Item Name: Crosstube Assembly, Mid Fwd

DART AEROSPACE LTD	Work Order: 98190
Description: Crosstube Assembly, Mid Fwd	Part Number: D206-667-147TRN
Inspection Dwg: D206-667-147 Rev: A	Page 1 of 2

DART AEROSPACE LTD HAWKESBURY, ONTARIO, CANADA	
DRAWING NO. D206-667-147	REV. A SHEET 1 OF 4
TITLE CROSSTUBE ASS'Y (206L MID FWD)	SCALE NTS

DRAWING NO. D206-667-147	TITLE CROSSTUBE ASS'Y (206L MID FWD)	REV. A	DART AEROSPACE LTD ENGINEERING ORDER		D.E.O. NO. D206-667-147-A-1	SHEET NO. SHEET 1 OF 1	SCALE NTS
DRAWN <i>q</i>	CHECKED <i>ASS</i>	MFG. APPR. <i>JB</i>	APPROVED <i>MD</i>		DE APPR. <i>JB</i>		
DATE 11.07.15	DATE 11.07.20	DATE 11.07.21	DATE 11/07/21		DATE 11.07.21

DETAIL P
BONDING STRAP INSTALLATION 2 PL

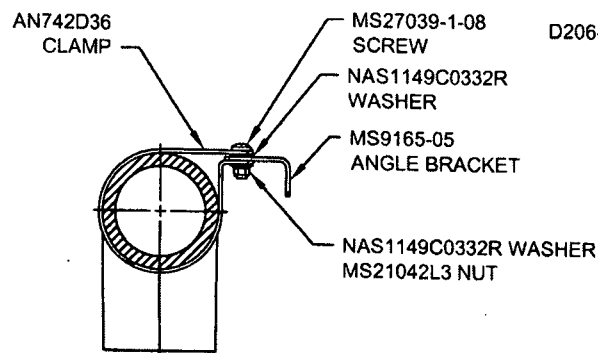
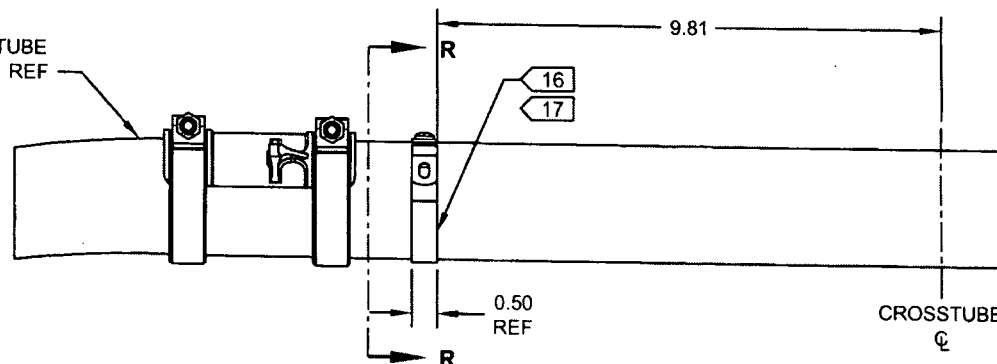
ADD ELECTRICAL GROUNDING STRAP

ITEM	QTY -147	PART NUMBER	DESCRIPTION
1	X	D206-667-147	CROSSTUBE ASSEMBLY (206L MID FWD)
10	2	AN742D36	CLAMP
11	2	MS9165-05	ANGLE BRACKET
12	2	MS21042L3	NUT (OR MS21042-3)
13	2	MS27039-1-08	SCREW
14	4	NAS1149C0332R	WASHER (OR AN960C10L)

- 16) MASK AREA UNDER CLAMP PRIOR TO PAINTING
- 17) SEAL EDGES WHERE AN742D36 CLAMP MEETS WITH THE CROSSTUBE USING SIKAFLEX-241/-291 OR MIL-S-8802 CLASS B2 OR PROSEAL 890 SEALANT
- 18) PERFORM RESISTANCE CHECK TO ENSURE MAX RESISTANCE IS 10 MILLIOHMS
